DEPARTMENT OF PLANNING AND INFRASTRUCTURE

SUBJECT: DETERMINATION OF THE PRE-DEMOLITION MANAGEMENT PLANS FOR THE PORT KEMBLA COPPER CHIMNEY STACK

Figure 3: The Exclusion Zone for the Stack Demolition

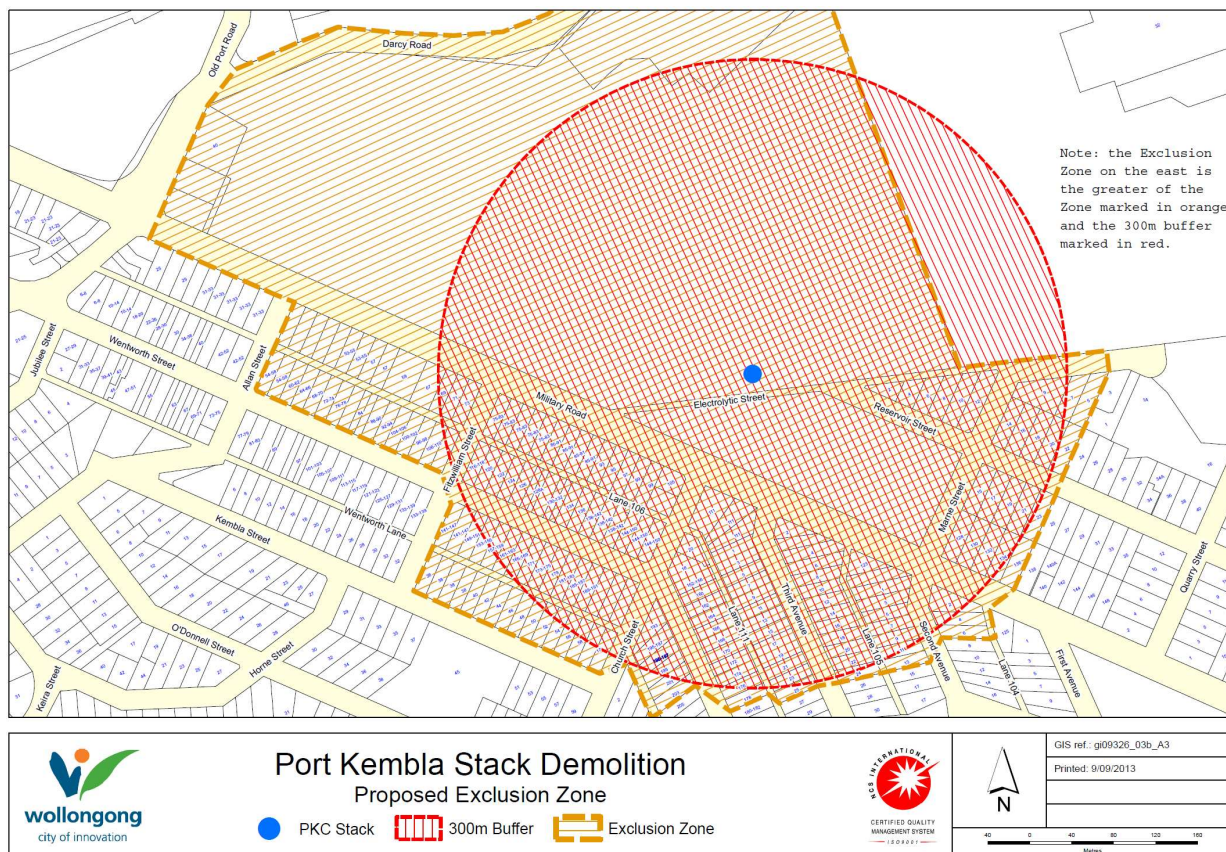
- provide an exclusion zone that meets the requirements of the relevant Australian Standards;
- provide written confirmation from WorkCover to demonstrate that it is satisfied with the size and extent of the exclusion zone and the preferred demolition expert;

At the Department’s request, PKC and its demolition expert consulted with WorkCover concerning the exclusion zone. WorkCover has agreed to the establishment of a 300m exclusion zone from the base of the stack, which meets the minimum requirements (1.5 times the height of the chimney) outlined in *Australian Standard 2601 – Demolition of Structures, 2001*. In addition to compliance with AS 2601, a broader exclusion zone is proposed towards the fall zone of the stack (ie to the north) of up to 500m (see Figure 3). This exclusion zone is also larger than the originally proposed 250m in the first draft of the pre-demolition management plans.

WorkCover has advised that it is satisfied with the proposed exclusion zone (see **Tag C**).

Figure 4: PKC's Proposed Dust Suppression Network

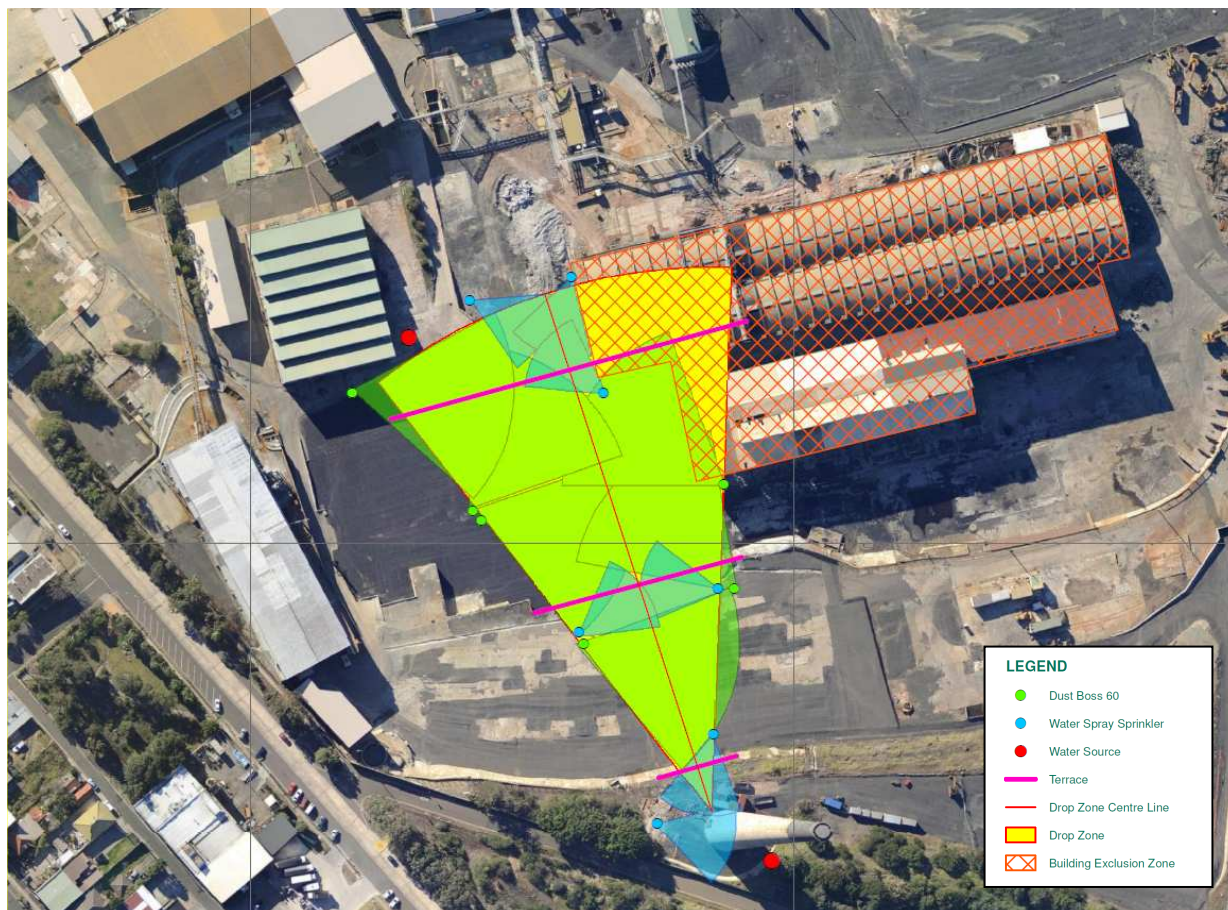
The EPA acknowledged PKC's commitment to clean up properties impacted by dust as a result of the stack demolition but requested that PKC develop a clean-up protocol prior to demolition to provide the community with clear procedures for cleaning impacted properties.

The Department acknowledges that there could be some off-site dust impacts on properties as a result of the stack demolition, the amount which would be determined by the wind direction and speed on the demolition day. Therefore, the Department recommends that PKC prepare a clean-up protocol prior to demolition to provide the community with a clear understanding of the procedures for cleaning properties that may be impacted upon by the stack demolition. The Department also notes that the conditions of the project approval require PKC to clean up any private property or business to the satisfaction of the Director-General.
